Technical Bulletin

Modification to Improve Reliability of Marquee Focus Module

*Applies to Focus Module (FCM)
with printed circuit board #50-002034-02P used in
Marquee 8110, 8500, 8500LC, 9500LC series projectors
manufactured between July 1st 1997 and April 20th 1998.
Also applies to service modules at issue 1 or 2.*

Figure 1

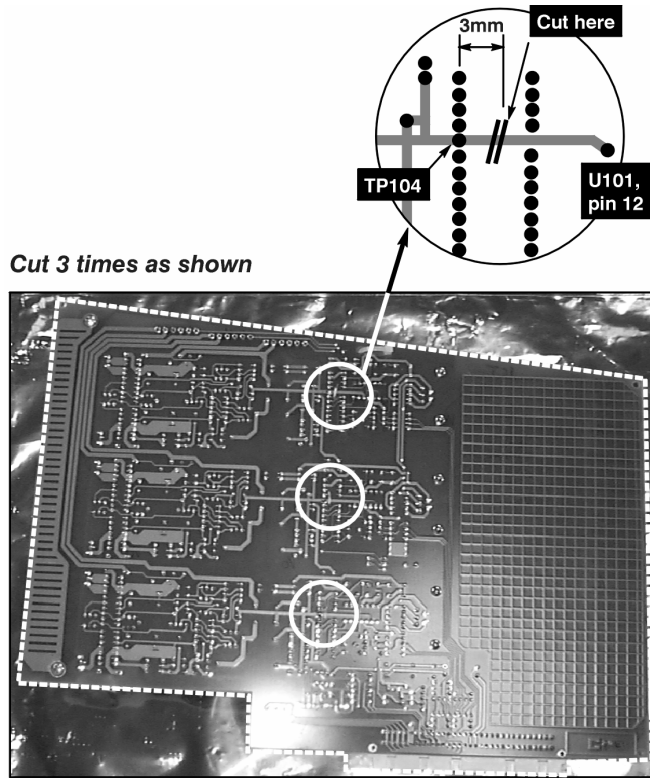
2. On the solder side of the FCM, locate the trace which runs between U101 pin 12 and TP104. Note that if TP104 is populated with a test point, it must be unsoldered and removed. Cut the trace approximately 3mm from TP104. **Be careful not to cut any of the adjacent traces.** See Figure 1.

3. On the solder side of the FCM, locate the trace which runs between U201 pin 12 and TP204. Note that if TP204 is populated with a test point, it must be unsoldered and removed. Cut the trace approximately 3mm from TP204. **Be careful not to cut any of the adjacent traces.** See Figure 1.

4. On the solder side of the FCM, locate the trace which runs between U301 pin 12 and TP304. Note that if TP304 is populated with a test point, it must be unsoldered and removed. Cut the trace approximately 3mm from TP304. **Be careful not to cut any of the adjacent traces.** See Figure 1.

Figure 2

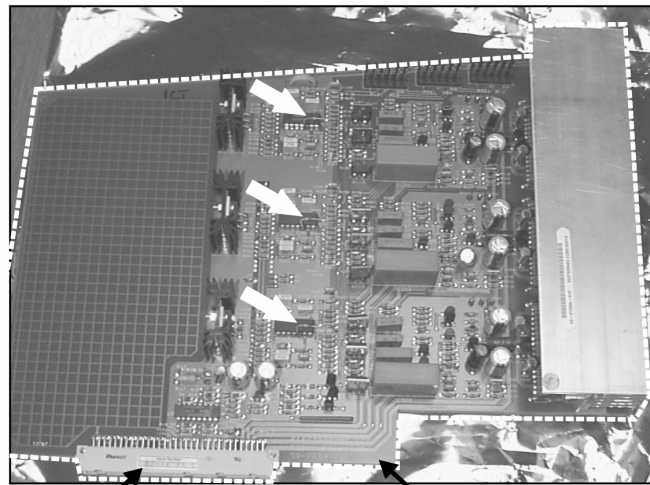
5. On the component side of the board, locate U101. Solder one leg of a 10k resistor (Electrohome part no. 80-110025-11P) to U101 pin 12, solder the other leg to TP104. The body of the resistor should be positioned on top of U101. See Figure 2.

6. On the component side of the board, locate U201. Solder one leg of a 10k resistor (Electrohome part no. 80-110025-11P) to U201 pin 12, solder the other leg to TP204. The body of the resistor should be positioned on top of U201. See Figure 2.

7. On the component side of the board, locate U301. Solder one leg of a 10k resistor (Electrohome part no. 80-110025-11P) to U301 pin 12, solder the other leg to TP304. The body of the resistor should be positioned on top of U301. See Figure 2.

Install new resistors

Issue 1 or 2 —
mark as issue 3
after modifying
